Access Compliance Report

Public Rights-of-Way

(Curb Ramps)

Intersection ID: 10041481	Main Street: WESTPARK_DR	Cross Street: N/A	Location: SE
ADA ID: 4D6413512DD4	Ramp Type: PerpDiag	Initial Pass/Fail: Fail	Overall Compliance: No
Severity Score: 21.25			
Codes/Mitigation Info/Possible Solution		Field Measurements/Component Compliance

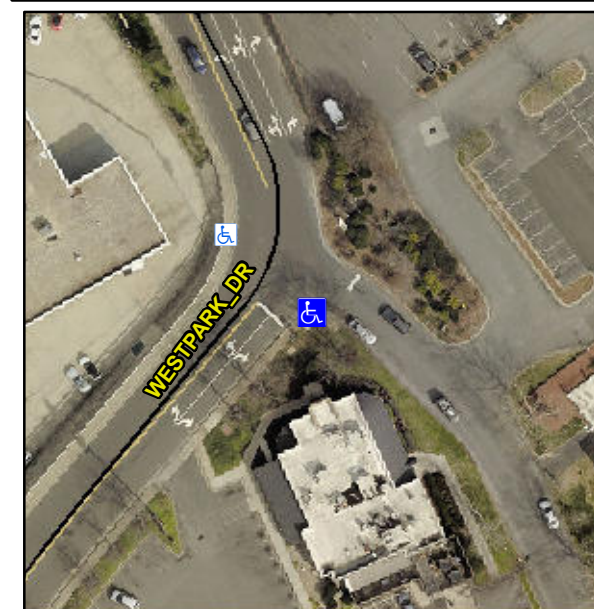
Not Found, R304.5.1, R304.2.2

Compliance	Description	Data	Compliance	Description	Data
N/A	Ramp Length (in)	59.0	No	Ramp Slope (%)	10.4
No	Ramp Width (in)	36.0	Yes	Ramp XSlope (%)	0.9
N/A	Flare Type LT	N/A	N/A	Flare Type RT	N/A
N/A	Flare Slope LT (%)	N/A	N/A	Flare Slope RT (%)	N/A
N/A	Flare Traversable LT?	N/A	N/A	Flare Traversable RT?	N/A
N/A	Landing Length (in)	N/A	N/A	DWS Provided?	N/A
N/A	Landing Width (in)	N/A	N/A	DWS Contrast?	N/A
N/A	Landing Slope (%)	N/A	N/A	DWS Length (in)	N/A
N/A	Landing X Slope (%)	N/A	N/A	DWS Full Width?	N/A
N/A	Landing Curb? (Y/N)	N/A	N/A	DWS Offset (in)	N/A
N/A	Shared Landing?	N/A			
N/A	Gutter Ponding?	N/A	N/A	Gutter Slope (%)	N/A
N/A	Gutter Lip Ht (in)	N/A	N/A	Gutter X Slope (%)	N/A
N/A	Painted X Walk1?	No	N/A	Painted X Walk2?	No
	X Walk 1 Direction	To NE		X Walk 2 Direction	To NW
N/A	X Walk 1 Width (in)	N/A	N/A	X Walk 2 Width (in)	N/A
	X Walk 1 Slope (%)	1.3		X Walk 2 Slope (%)	1.2
	X Walk 1 X Slope (%)	0.8		X Walk 2 X Slope (%)	1.8

Remove & Replace Curb Ramp With Two New Directional Ramps or Equivalent.
